**CHAIR AND PLANNING COMMISSIONERS**

City of Long Beach

Recommend that the City Council 1) certify the revised Final Environmental Impact Report (EIR 03-16) based on the final set of maps approved by the Long Beach City Council on March 6, 2018; 2) adopt the updated Land Use Element to the Long Beach General Plan; 3) adopt the new Urban Design Element to the Long Beach General Plan; and 4) repeal the existing Scenic Routes Element to the Long Beach General Plan. (Citywide)

LUE, EIR, UDE

Expansion of the height and density north side of street at PCH & Pacific Avenue from 2007 to present (CD #6).

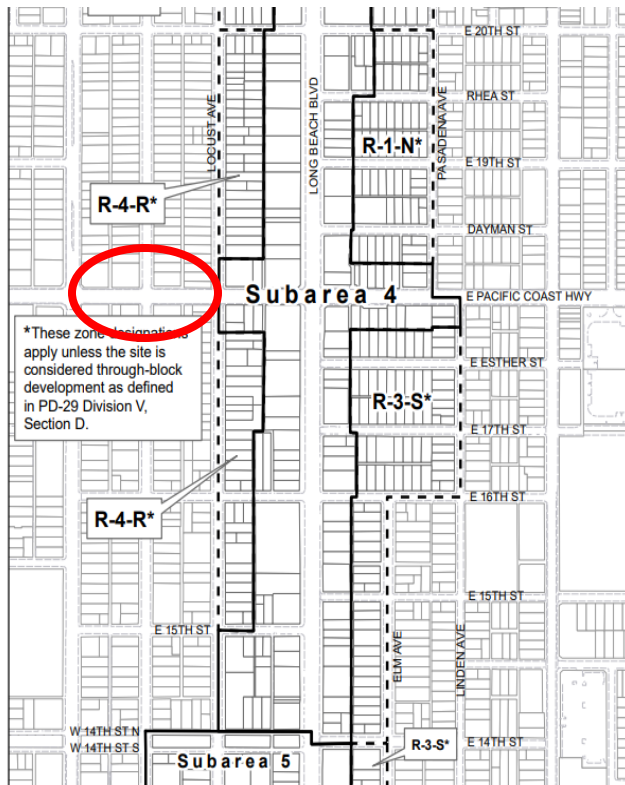
**Comply with the height map for the Midtown plan figure 3-4 building and street wall height standards approved in 2016.**

Please follow the height shown in the Midtown Plan along PCH between Locust and Pacific Avenue. This plan was approved only 3 years ago. The Long Beach Boulevard Planned Development District (PD-29) (2007) plan ended at the north/south alley west of Long Beach Blvd. and had a height limit of 50 feet. The Midtown Plan approved in 2016 changed this 50 foot height limit to 10 stories and expanded the plan boundary from Locust Avenue to Pacific Avenue (east side of Pacific Avenue only with a 5-story height limit). The Midtown Plan expanded the plan boundary by two full blocks and changed it from 2 to 5 stories. The current proposal is to extend the 10 story height from Locust Avenue to Pacific Ave (east side of the street). The 2016 Midtown Plan expanded the area (Previously PD-29) by 42 acres into the surrounding neighborhood. Now once again there is a proposed further encroachment into the neighborhood adding more density and height that is not compatible in any manner. The proposed height increase from 2 stories at PCH west of Pacific to 7 stories and 5 stories east of Pacific Avenue to 10 stories. That is an 5 story increase west of Pacific Avenue and a 5 story increase east of Pacific. Can you imagine an 8 story increase over 12 years on the east side? Residents there were upset over a 1 story increase at Palo Verde and Spring so that was reduced back down to 2 stories except for an existing 3 story building. This area now has a height taller than Long Beach Blvd outside of the metro stations. There are currently one story buildings on all four corners. So at the gateway to Wrigley there will be a ten story building on one side and 7 stories on the other side of Pacific Avenue. This encroachment is way to far into the neighborhood. The ten story height should stop at Locust Avenue as it does in the Midtown Plan, which was approved 3 years ago. The plan encroaches two more city blocks into the neighborhood. If you are familiar with Galaxy Towers in Bluff Park this will be similar to that development. A 10 story structure next to 2 story buildings is completely incompatible and will result in a huge loss of privacy for homeowners within at least a 7 to 8 block area.

Developers have the support of the council person, but the residents have no one to represent their concerns. Please consider the fairness of the distribution of density.

**Request: Comply with the Midtown Plan Height Map as approved in 2016 for PCH west of Locust Avenue. Maintain the 5-story height limit on PCH between Locust Avenue and Pacific Avenue as shown on Figure 3-4 page 63 of the Midtown Plan. (Shown below).**

2019 Proposed LUE map

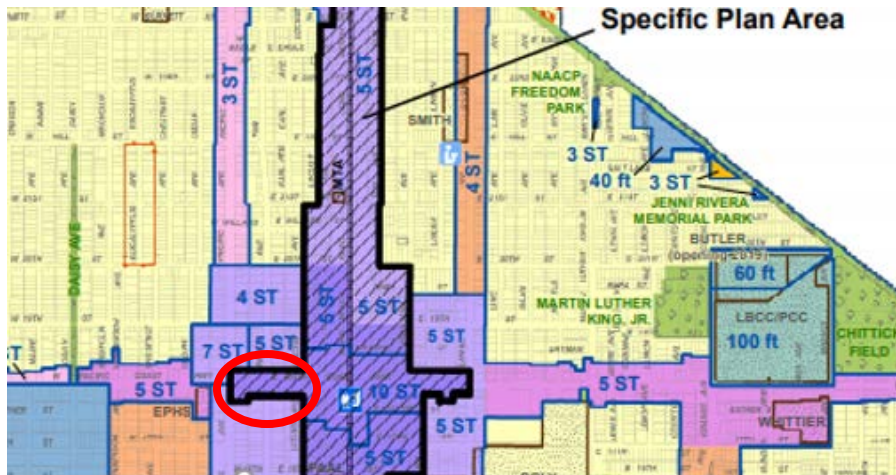
**Request: Change the east side of Cedar Avenue, except for the first four lots north of PCH, back to Founding and Contemporary Neighborhoods (N) as it was shown on the 2017 LUE map (below), change the height from 7 to 5 stories along the rest of Pacific Avenue on both sides of the street from PCH to 19<sup>th</sup> Street.**

LUE Map of 6th District after the March 2018 City Council Meeting

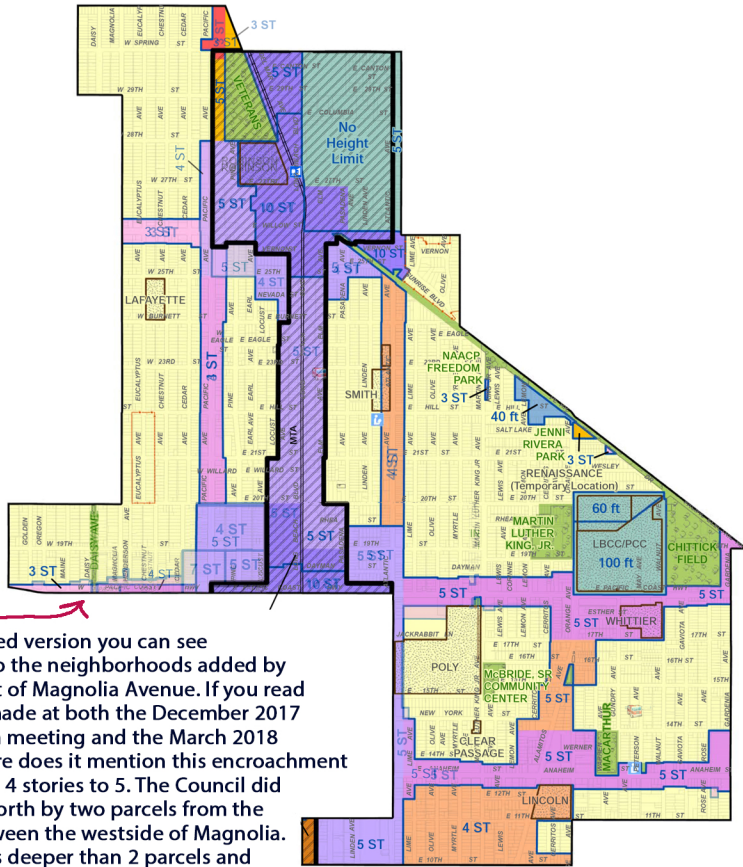
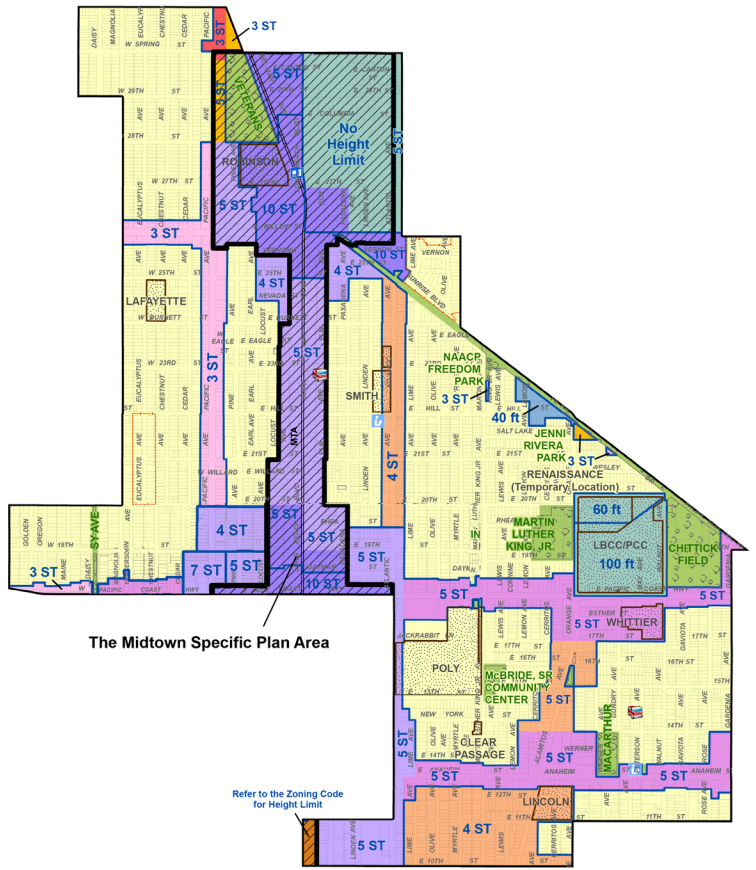
Attached is a PDF of the 6th district map with overlays. The first page shows what we think is an error in the map, there seem to be overreaches along PCH from Cedar west. Pages 2 through 4 are the motions found on the Cities website.

In this overlaid version you can see the encroachment into the neighborhoods added by City Staff along PCH west of Magnolia Avenue. If you read the list of adjustments made at both the December 2017 Planning Commission meeting and the March 2018 City Council meeting, nowhere does it mention this encroachment or height change from 4 stories to 5. The Council did extend the NSC-M north by two parcels from the westside of Cedar between the westside of Magnolia. Henderson appears deeper than 2 parcels and everything west of Magnolia should be as it was in the December 2017 map.

Our hope these encroachments can be corrected.
